ADDENDUM NO. 2
TO THE
CONTRACT DOCUMENTS
FOR
RAW WATERLINE REPLACEMENT
FOR
CITY OF WARRENTON

MURRAYSMITH
400 E Mill Plain Blvd, Suite 400
Vancouver, WA 98660
(360) 448-4230

RAW WATERLINE REPLACEMENT

CONNECT TO EX 24" FRP RW 3
SCALE: NTS

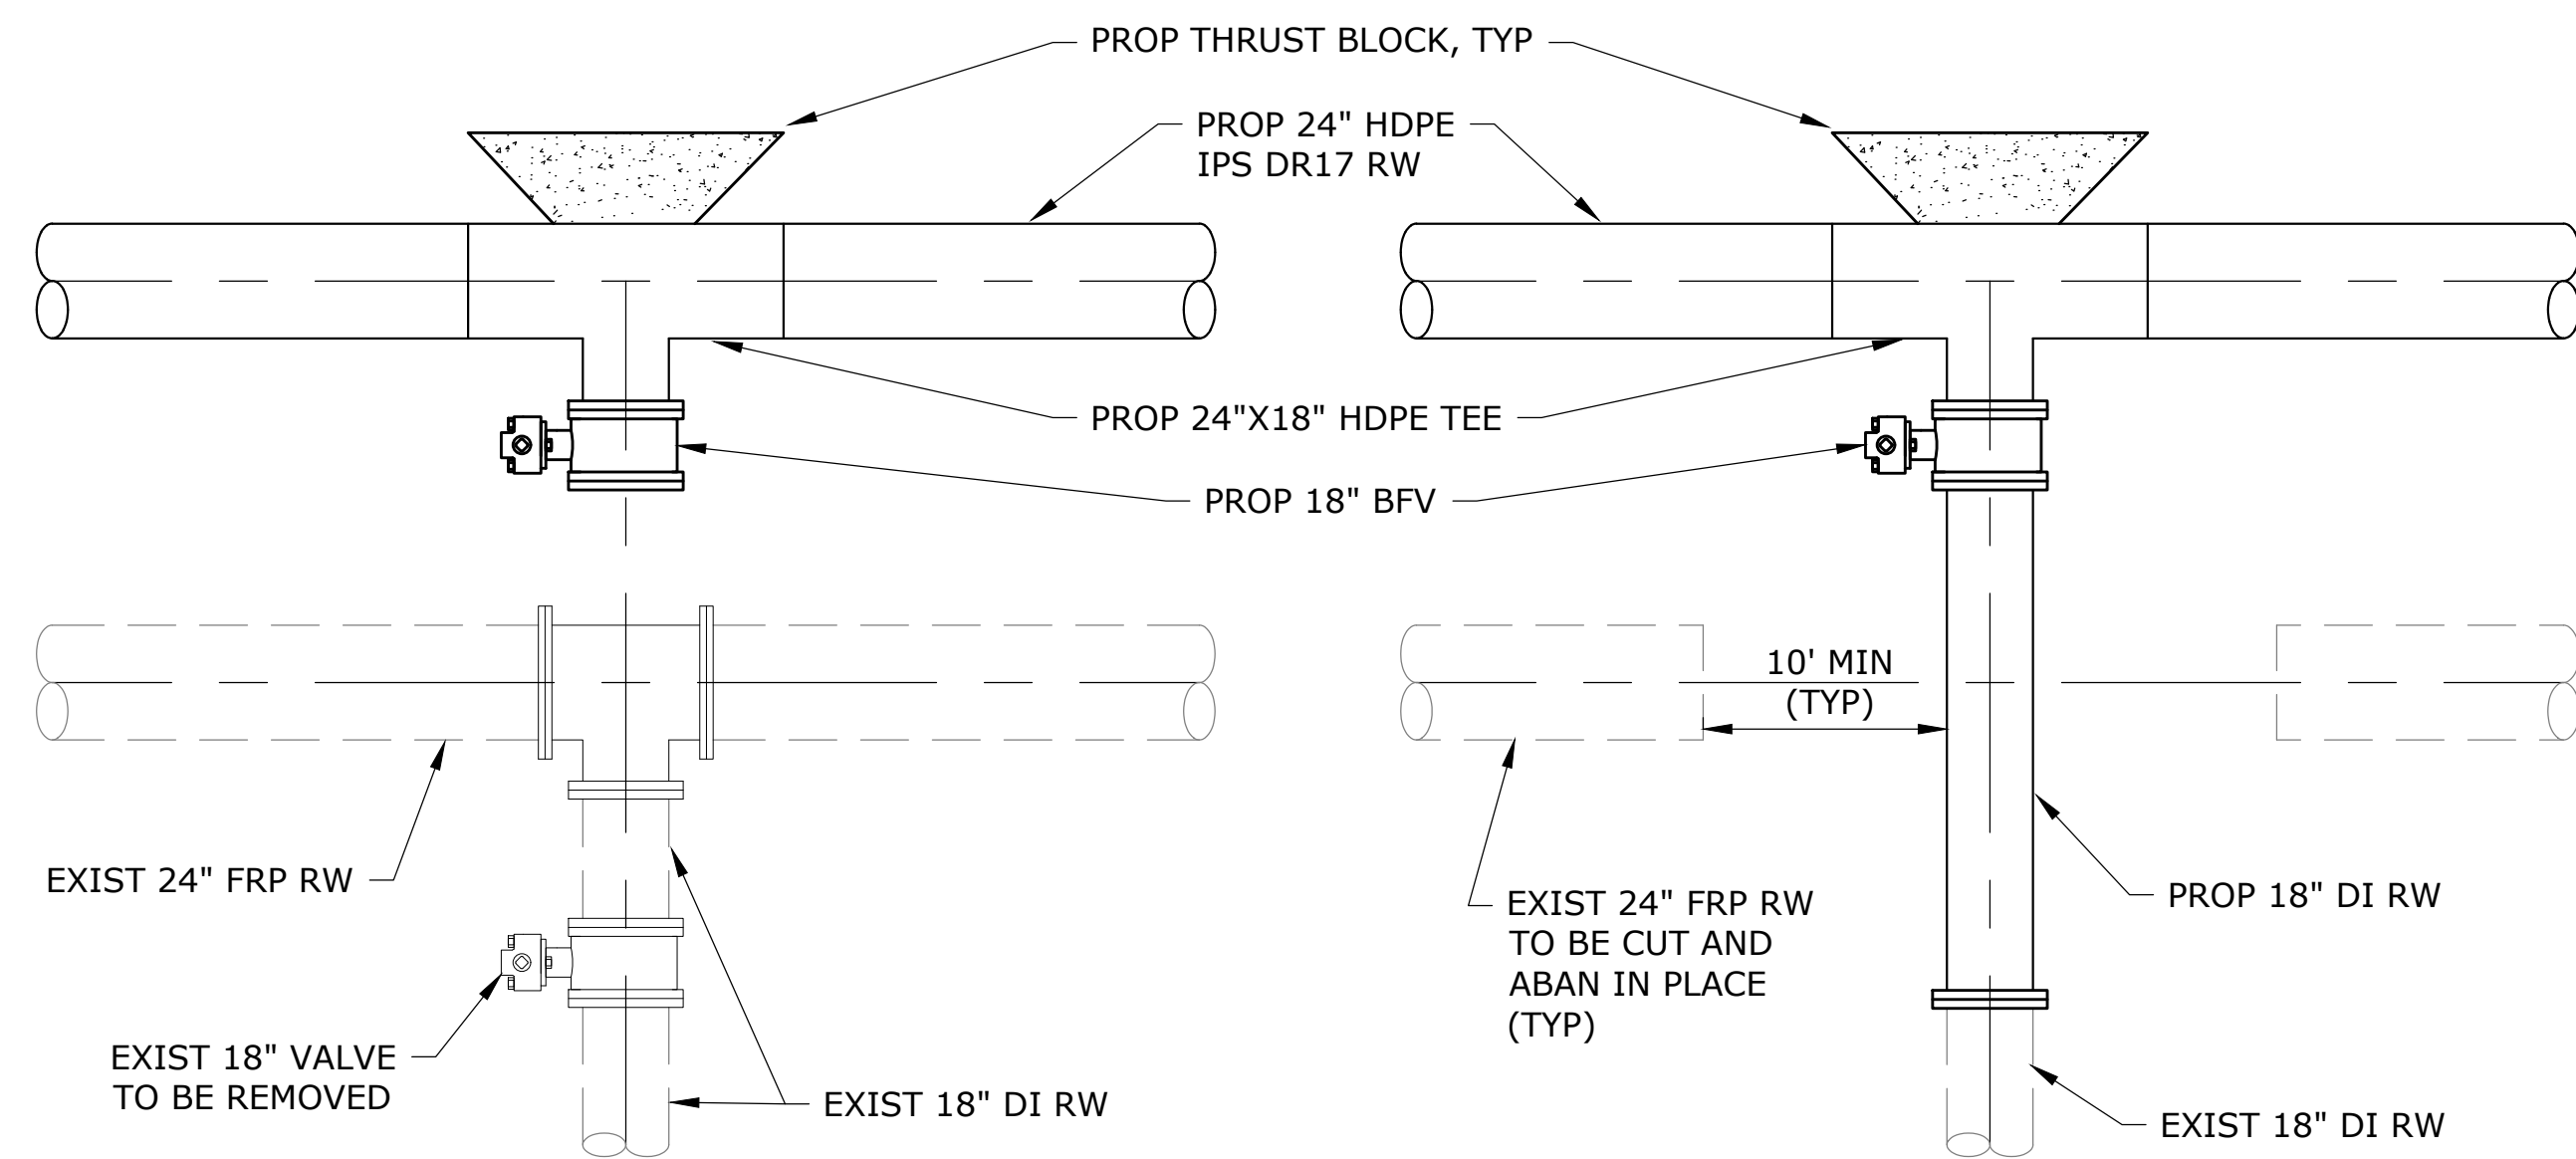
C-6, DETAIL 3, CONNECT TO EX 24" FRP RW: Added proposed collar thrust block to location indicated.

COLLAR THRUST BLOCK

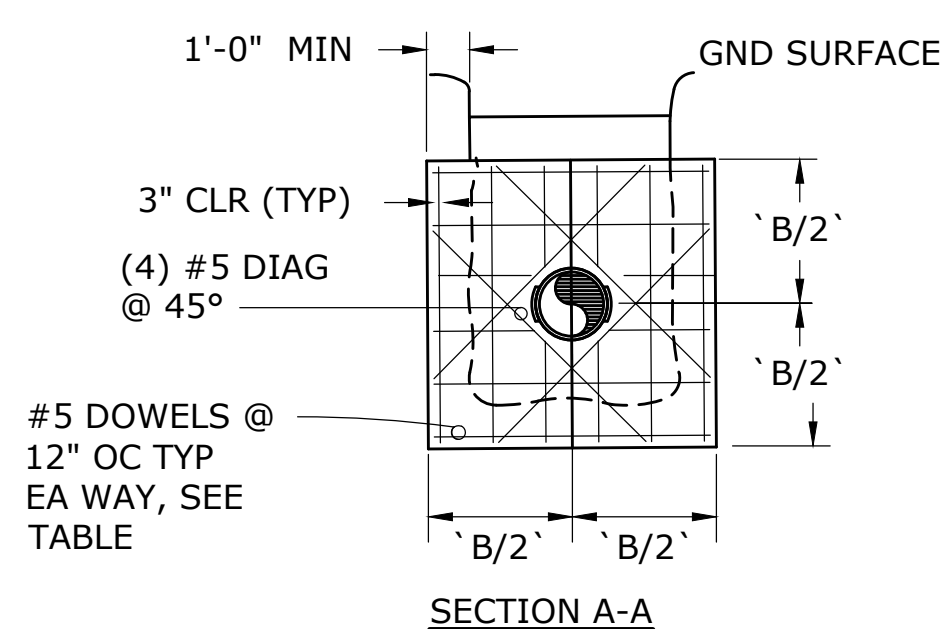
C-7, DETAIL 4, COLLAR THRUST BLOCK: Added plan view and notes. Updated table with block dimensions, dowels and flex restraints quantity.
